Release Notes

Hardware Change: Ranger[®]/RG 2200 Series Extender Systems Metal Faceplates

Document #: 90-01301
Faceplate Release Date: November 2014
Version: A01

Figure 1 Previous faceplates with ground tap marker and symbol

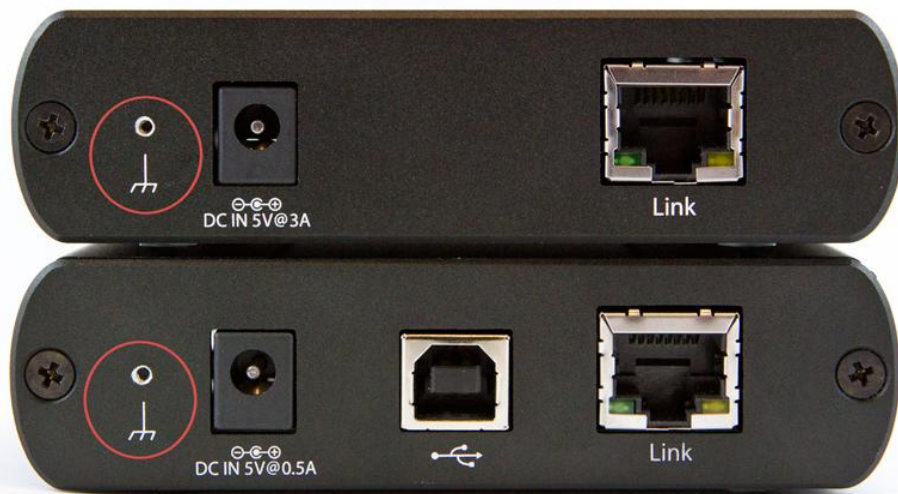
The rear faceplates of both the local and remote extender units have been revised by removing the ground tap marker (and associated symbol) and the voltage text has been simplified to read as 5VDC. These changes apply to both silver and black faceplates.

Optional grounding capability (if required) is still available by connecting a screw and grounding wire to any one of the four pre-threaded mounting holes on the bottom of the enclosures. The previous grounding process required drilling into the marker on the rear faceplate.
